Addendum No. 1

From: David Mason & Associates

Project: Central Riverfront Leonor K. Sullivan Boulevard and Bikeway

Project Number: TDG-0705 (333) Project 2

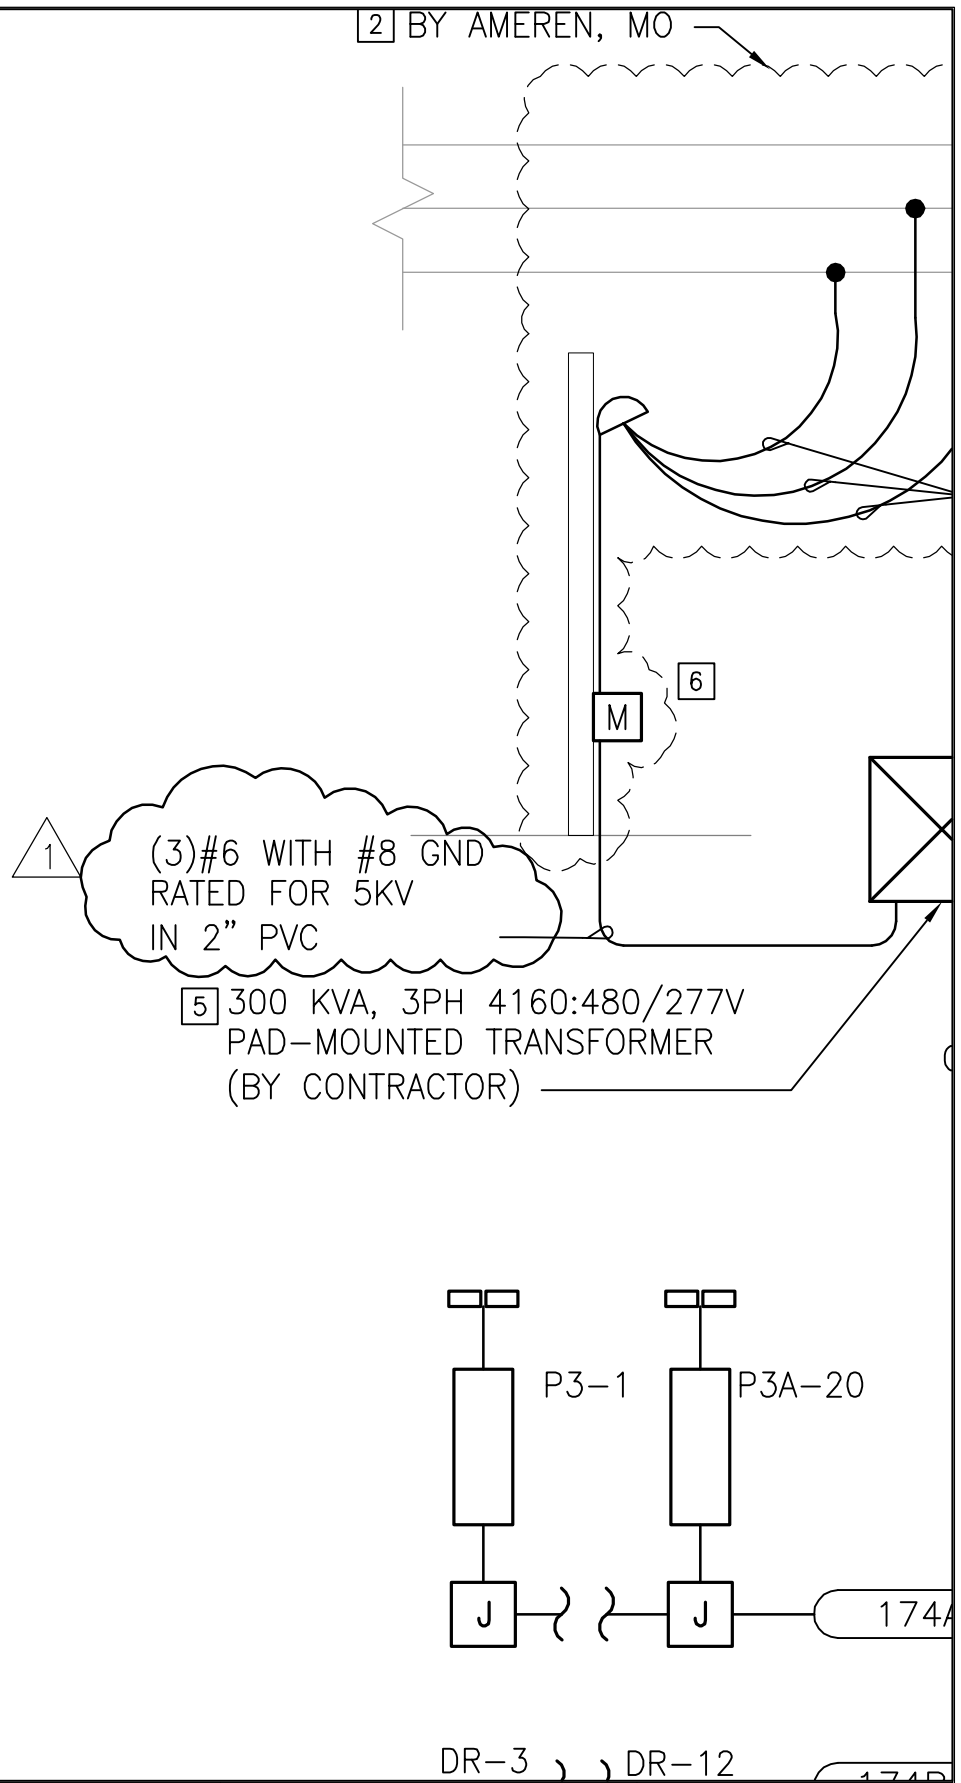
Sheet E1.03 Electrical Plan:

1. The note calling out (14) 5” conduits should read (6) 5” conduits. See attached Sketch 1 for Sheet E1.03.

Date 10/11/2013
Job No. TDG-0705(333) Project 2
Sheet No. E2.20 - SK 1

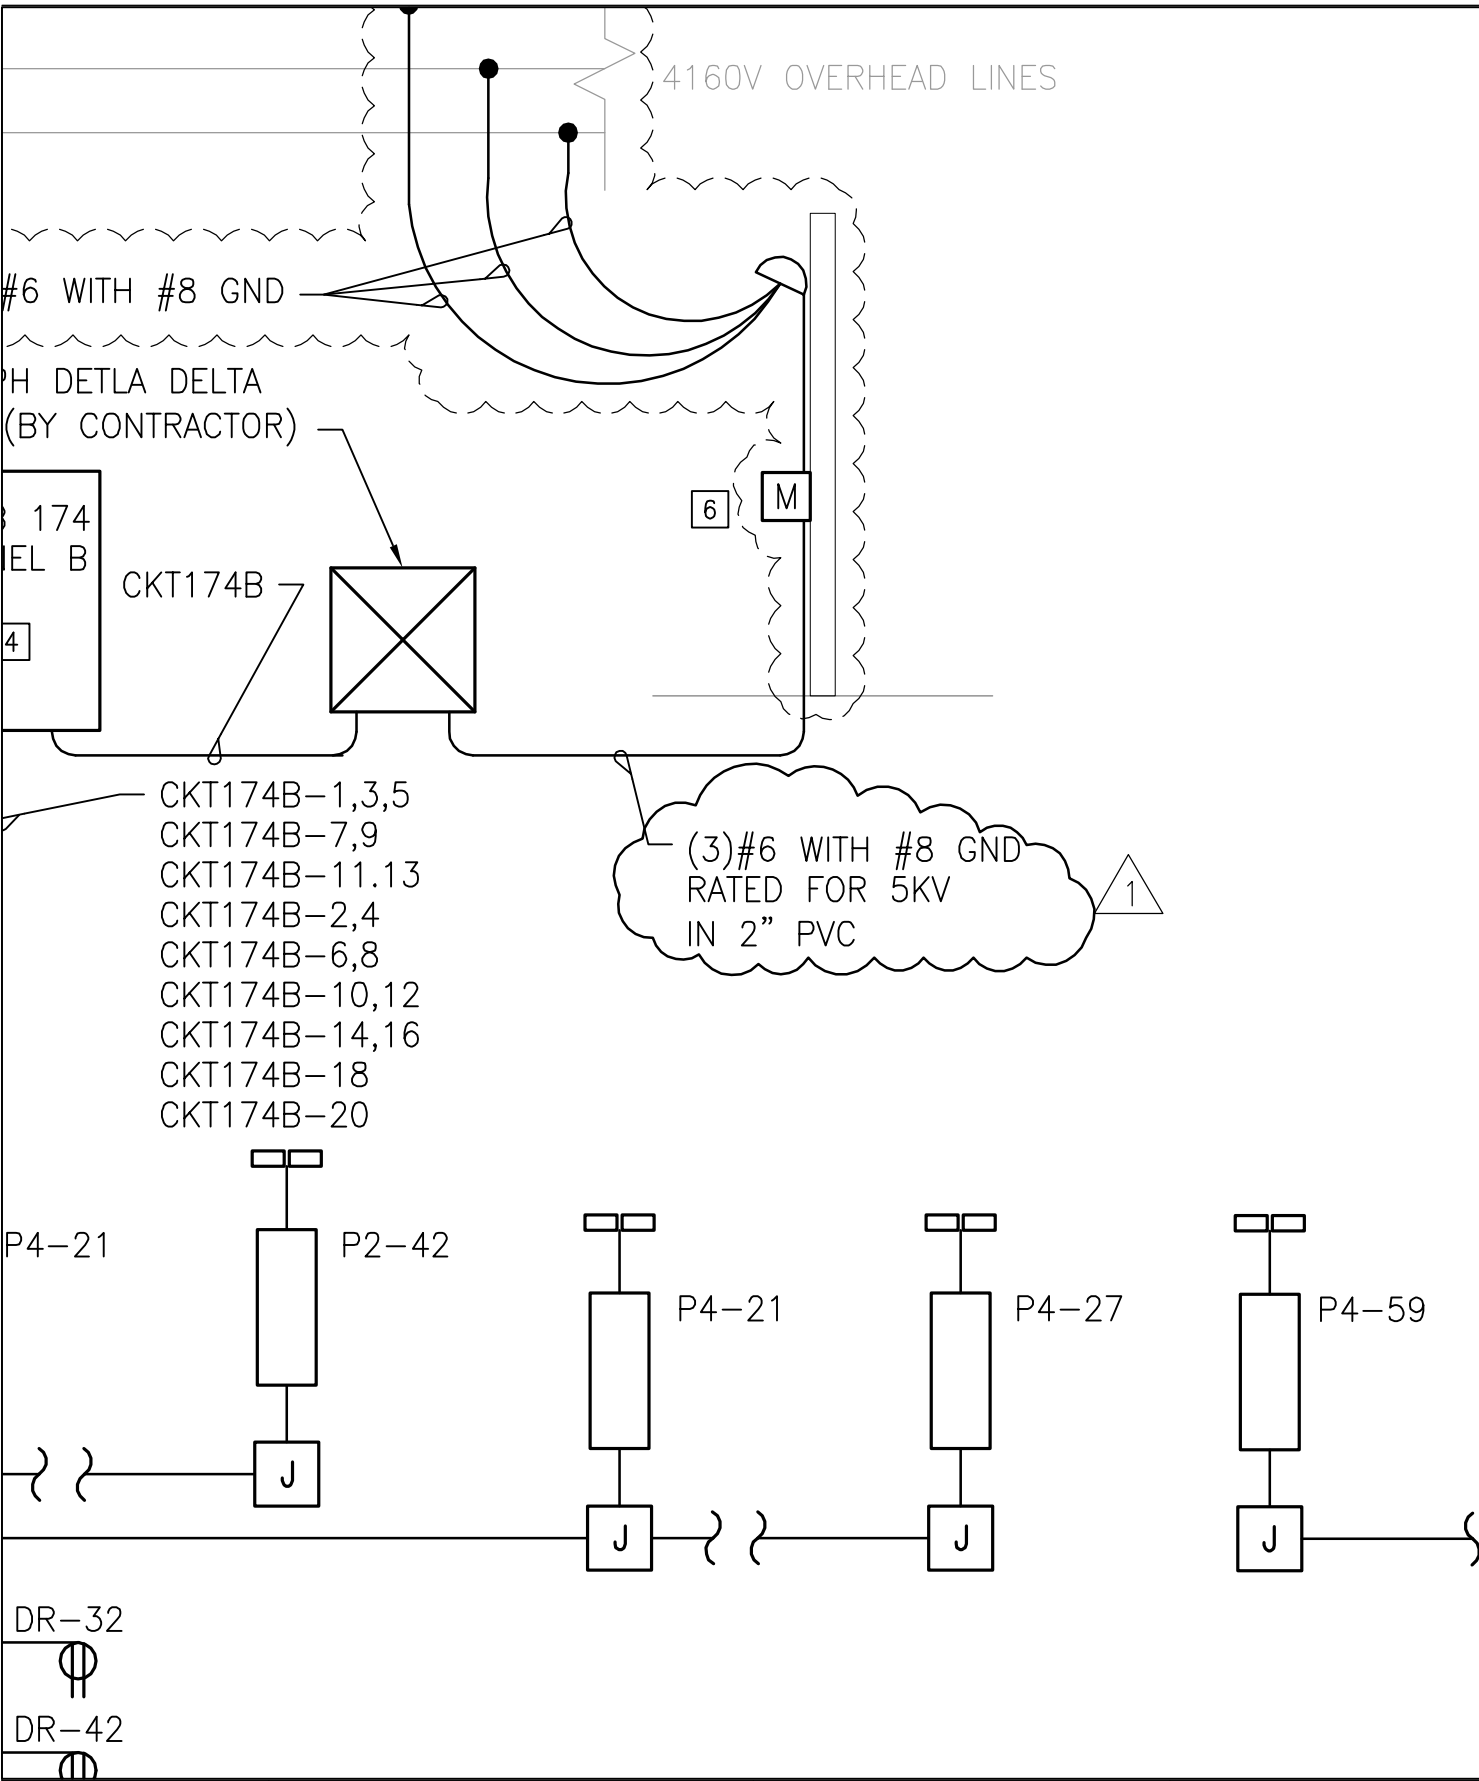
Sheet E2.20 Substation One-Line:

1. The service wire on the line side of the transformers should be rated for 5kV. See attached Sketches 1 and 2 for Sheet E2.20.

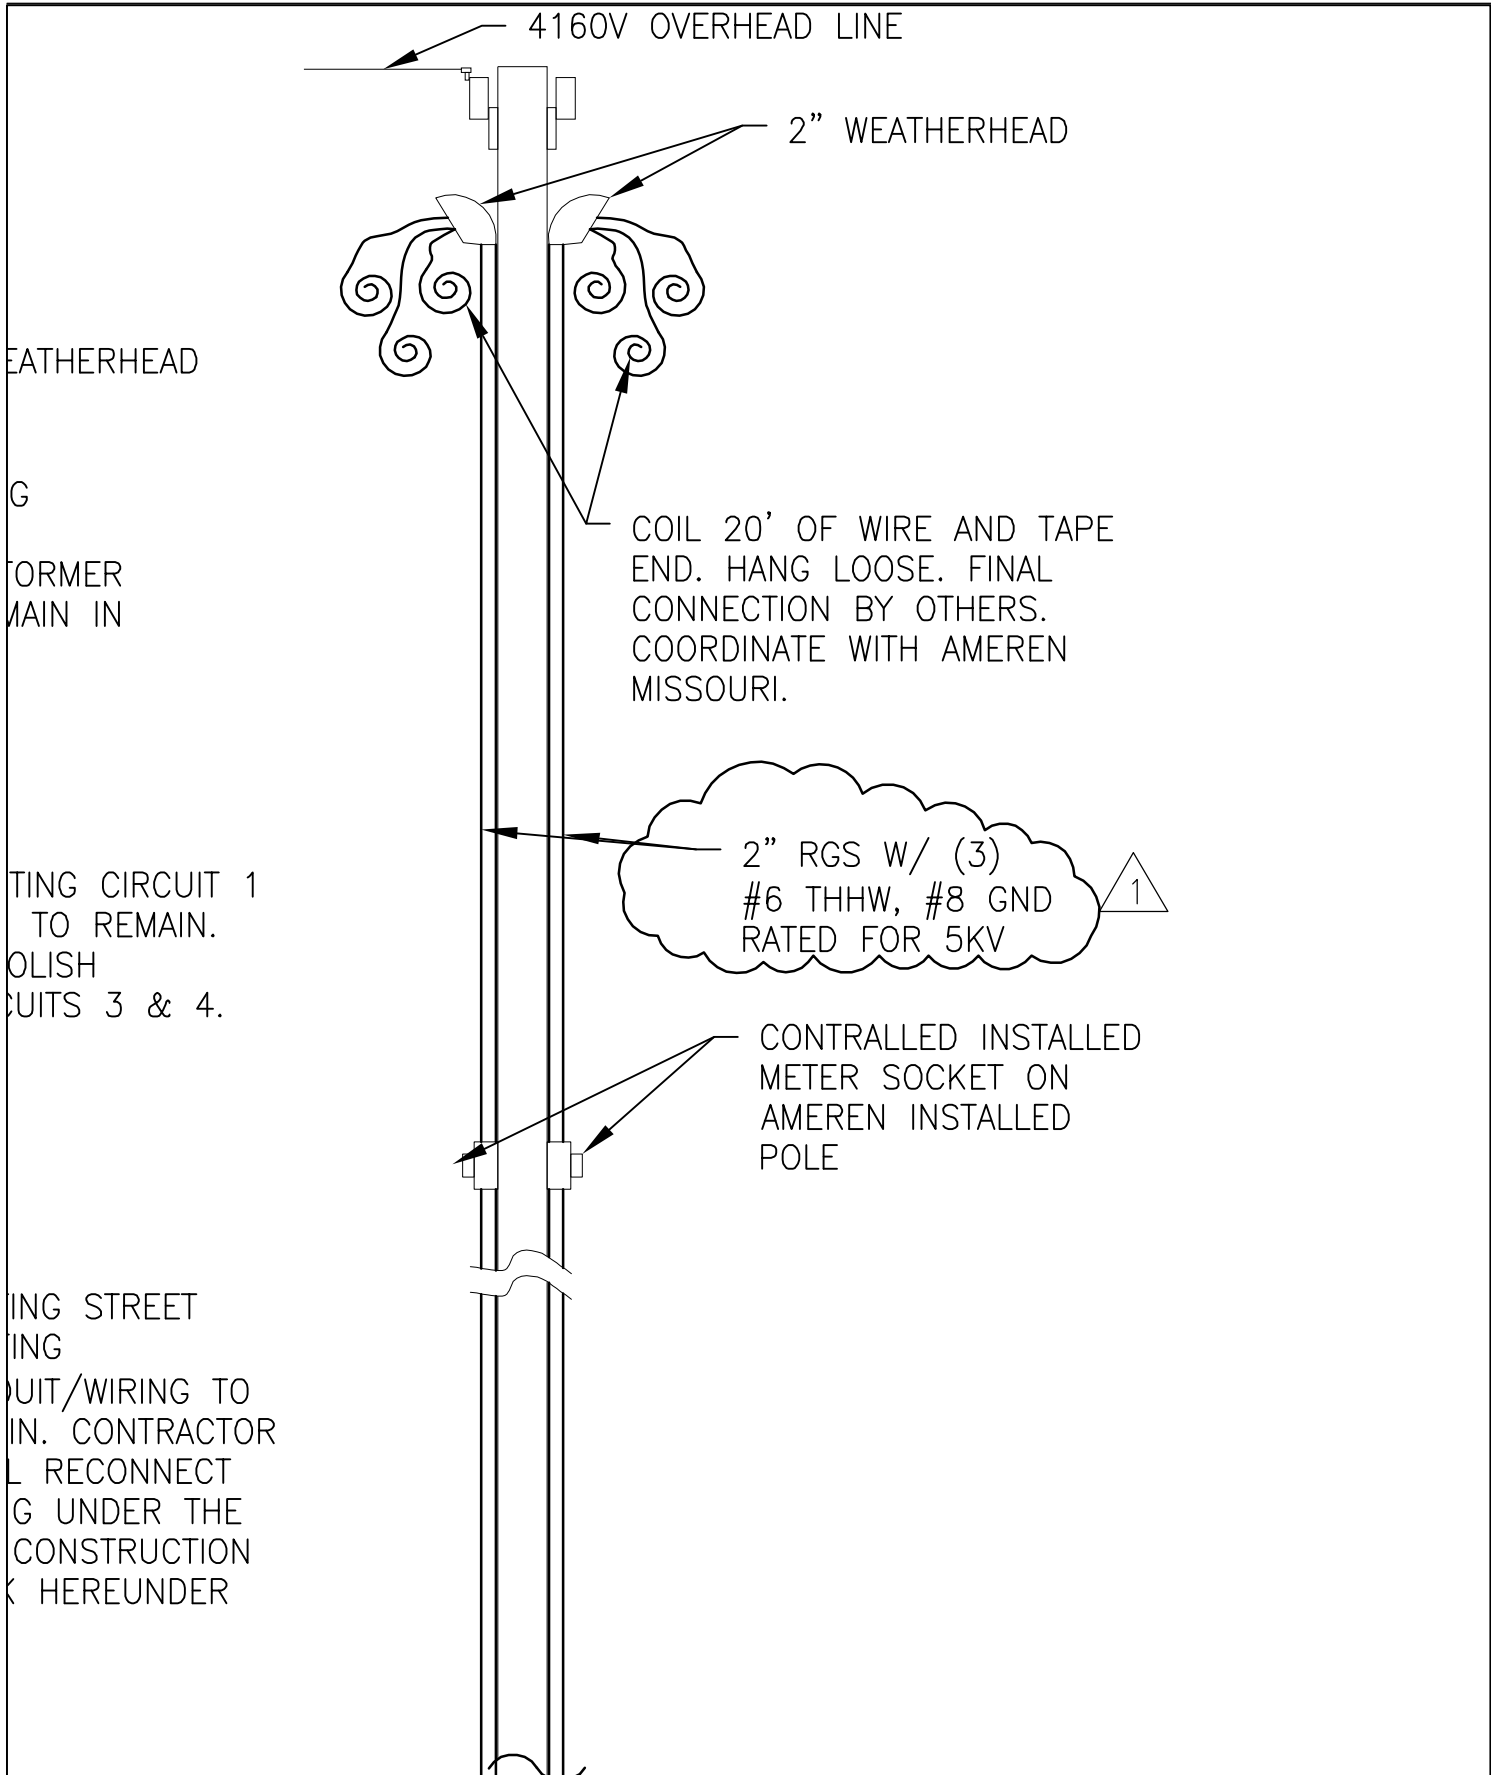
Sheet E2.23 Electrical Details:

1. The service wire on the line side of the transformers should be rated for 5kV. See attached Sketch 1 for Sheet E2.23.
1. 4/0 Bare copper ground has been drawn in the utility electrical duct bank detail. See attached Sketch 2 for Sheet E2.27.
